SB: **Garden Pump 3000/4**

Article : **1707**

Reason: Danger of overtorquing the draining plug.

Spare parts: New locking screw, red art.-no. 1707-00.900.21

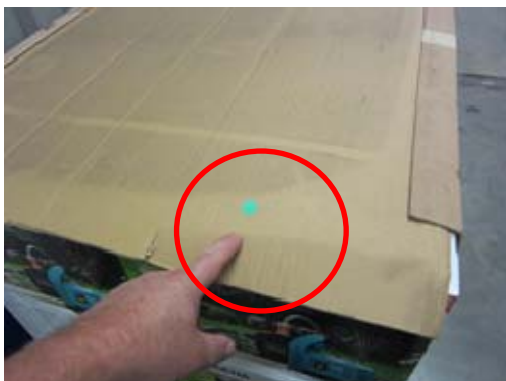
On pumps before index 1406H it can happen that the thread for the draining plug inside the pump body is too short and can be overtorqued . For service purposes a new draining plug with a longer thread was created as a spare part. These plugs will fit on pumps with index later than 1406H too.

Actions: Modification of the thread in the pump body since index 1406H

Rework : The whole stock in Ulm was reworked and these pumps can be identified by a mark beside the index and a green sticker on the box and the palett :
